LiDAR Quality Assessment Report

Project ID:
OR_CVO-Burns_2011

Year of Collection: 2011

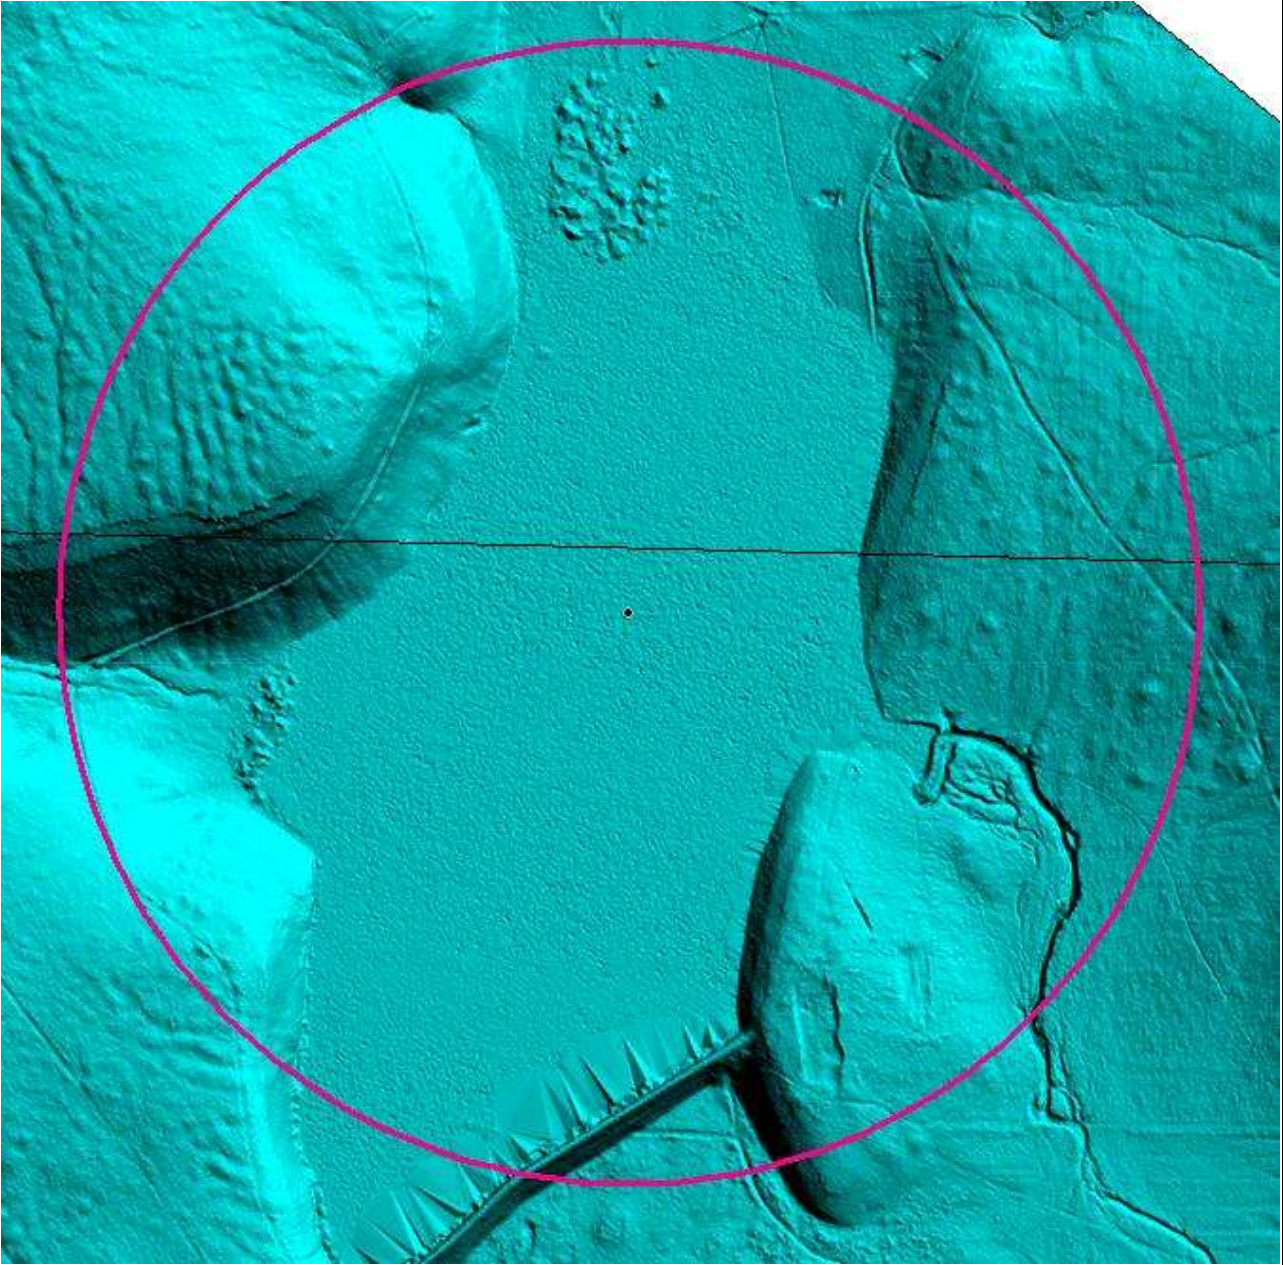
Waterbody not flattened. Reviewer at NGTOC created an "errors" shapefile located in the METADATA-Shapefiles folder named errors.shp.

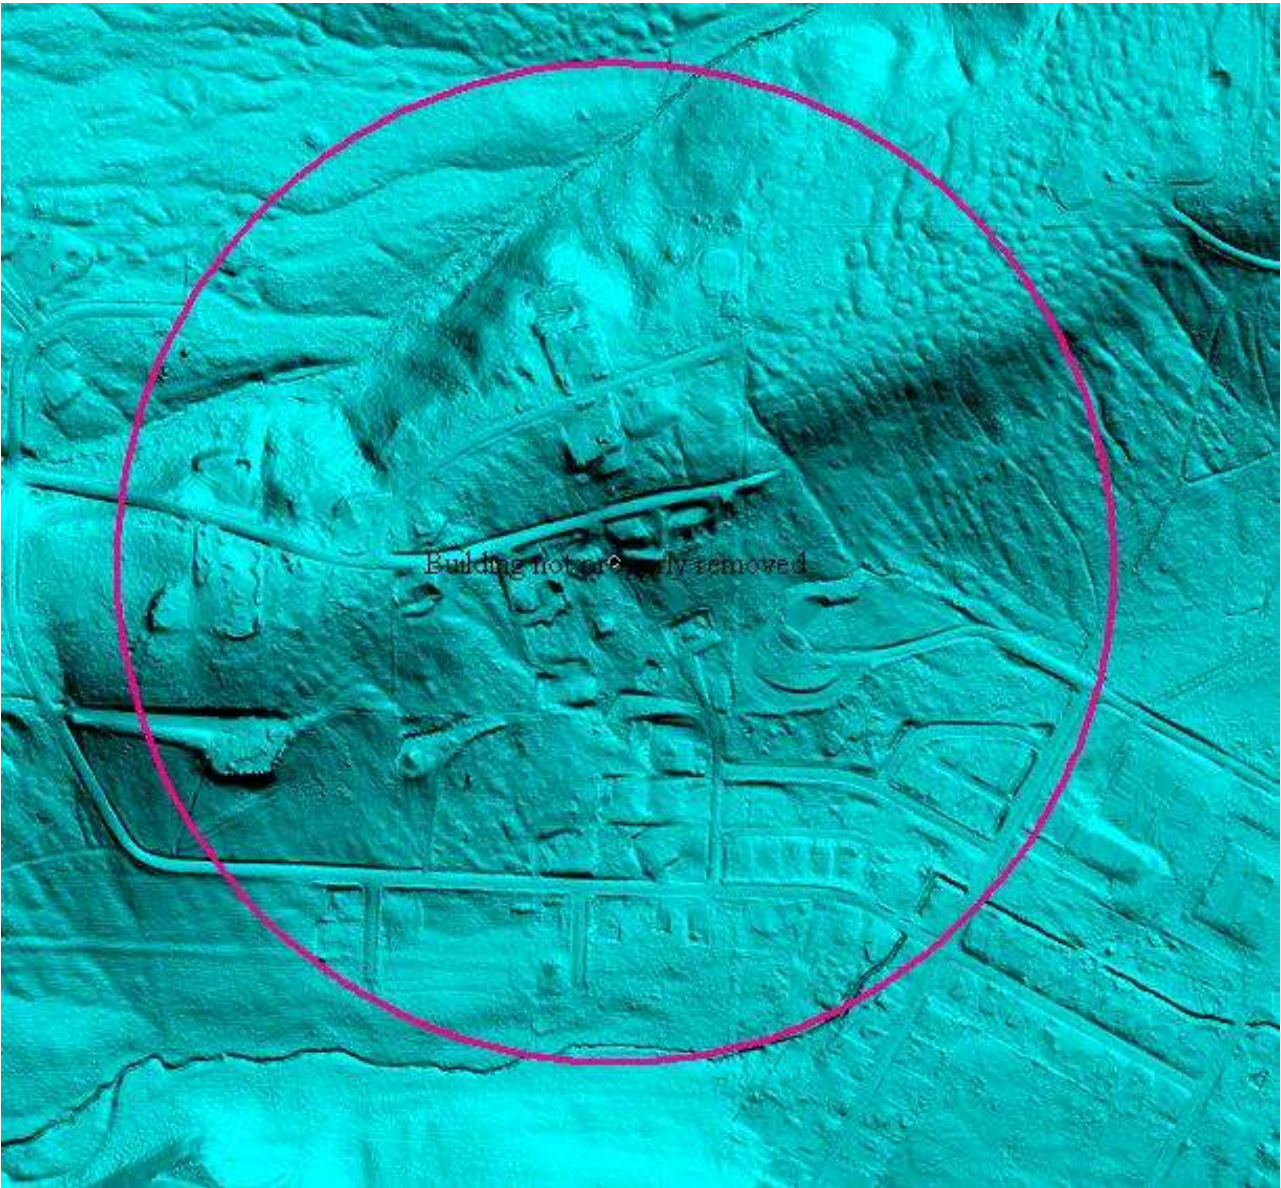
Buildings not properly removed. Reviewer at NGTOC created an "errors" shapefile located in the METADATA-Shapefiles folder named errors.shp.
